SOLAR PROJECT
BAKERS FALLS SOLAR, LLC

11-15 ELECTRIC DRIVE
 TOWN OF MOREAU
 SARATOGA COUNTY, NEW YORK

SHEET TITLE:
 DECOMMISSIONING PLAN

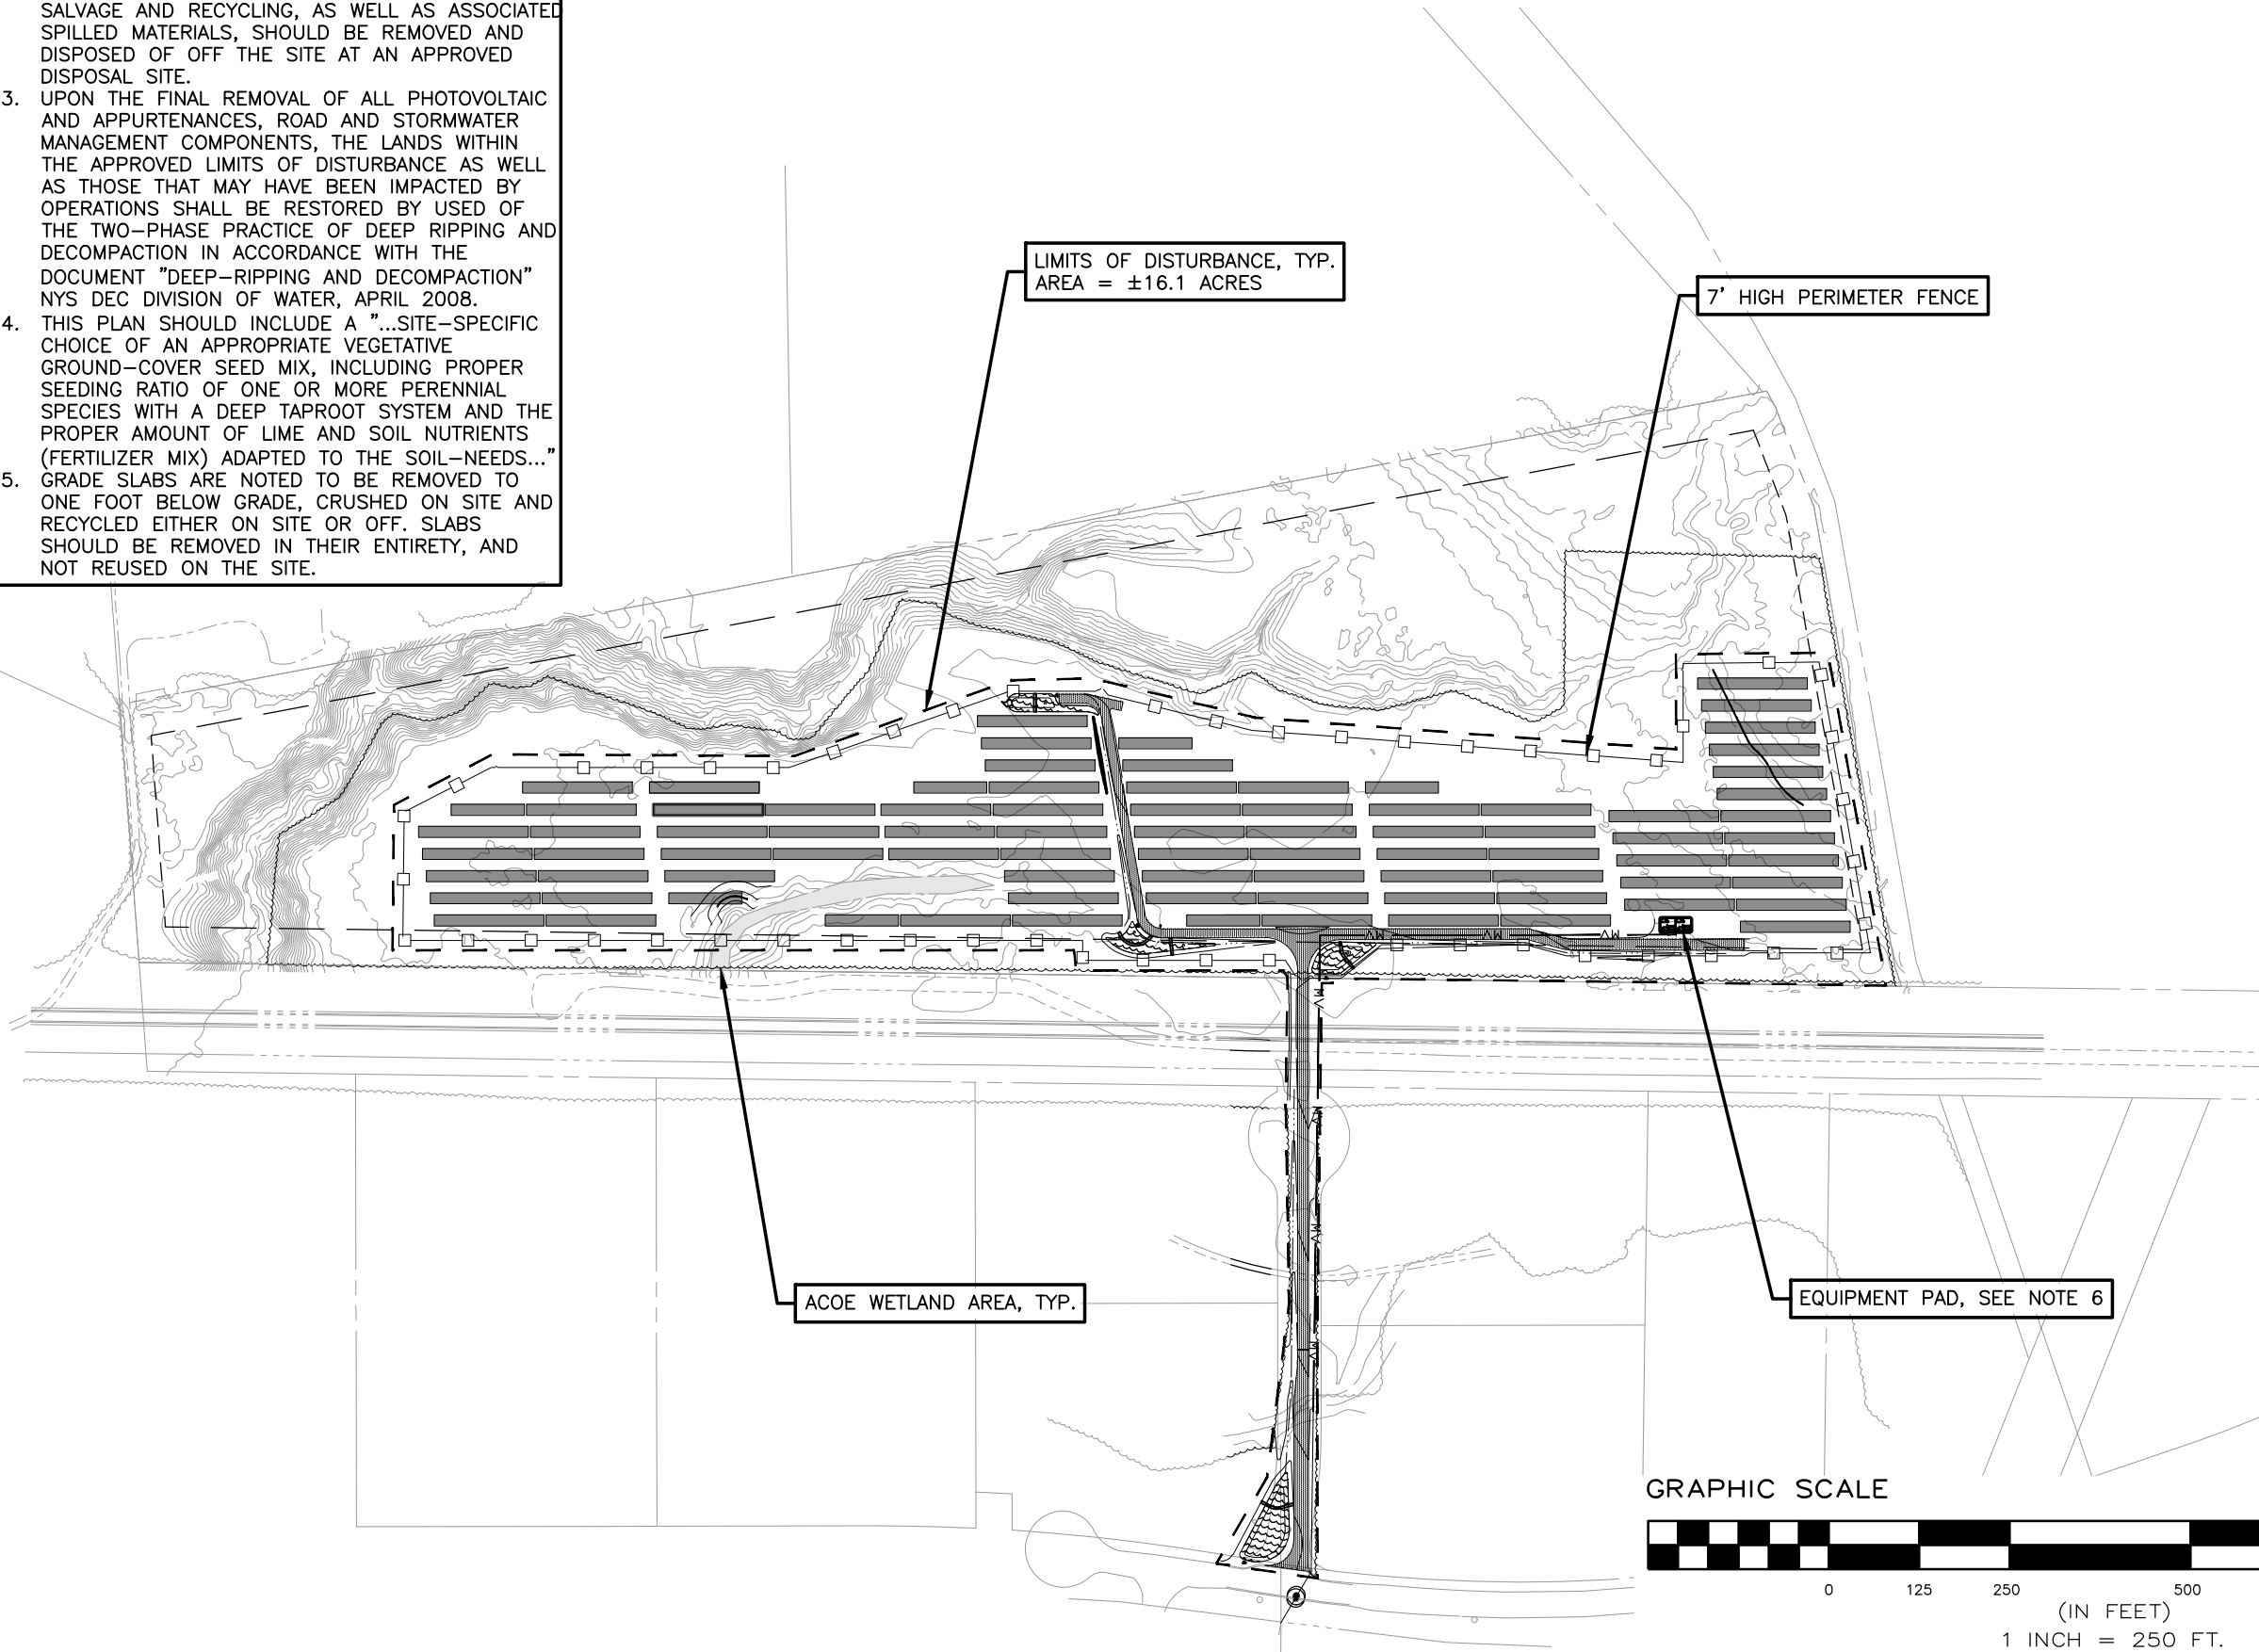
1. ALL CONNECTORS/CONNECTIONS THAT ARE CUT OR DISMANTLED SHOULD BE REMOVED AND DISPOSED OF OFF THE SITE AT AN APPROVED DISPOSAL SITE.
2. ALL SOLAR CELL "MODULES" CRACKED, FRACTURED, OR OTHERWISE UN-SUITABLE FOR SALVAGE AND RECYCLING, AS WELL AS ASSOCIATED SPILLED MATERIALS, SHOULD BE REMOVED AND DISPOSED OF OFF THE SITE AT AN APPROVED DISPOSAL SITE.

3. UPON THE FINAL REMOVAL OF ALL PHOTOVOLTAIC AND APPURTENANCES, ROAD AND STORMWATER MANAGEMENT COMPONENTS, THE LANDS WITHIN THE APPROVED LIMITS OF DISTURBANCE AS WELL AS THOSE THAT MAY HAVE BEEN IMPACTED BY OPERATIONS SHALL BE RESTORED BY USED OF THE TWO-PHASE PRACTICE OF DEEP RIPPING AND DECOMPACTION IN ACCORDANCE WITH THE DOCUMENT "DEEP-RIPPING AND DECOMPACTION" NYS DEC DIVISION OF WATER, APRIL 2008.

4. THIS PLAN SHOULD INCLUDE A "...SITE-SPECIFIC CHOICE OF AN APPROPRIATE VEGETATIVE GROUND-COVER SEED MIX, INCLUDING PROPER SEEDING RATIO OF ONE OR MORE PERENNIAL SPECIES WITH A DEEP TAPROOT SYSTEM AND THE PROPER AMOUNT OF LIME AND SOIL NUTRIENTS (FERTILIZER MIX) ADAPTED TO THE SOIL-NEEDS..."

5. GRADE SLABS ARE NOTED TO BE REMOVED TO ONE FOOT BELOW GRADE, CRUSHED ON SITE AND RECYCLED EITHER ON SITE OR OFF. SLABS SHOULD BE REMOVED IN THEIR ENTIRETY, AND NOT REUSED ON THE SITE.
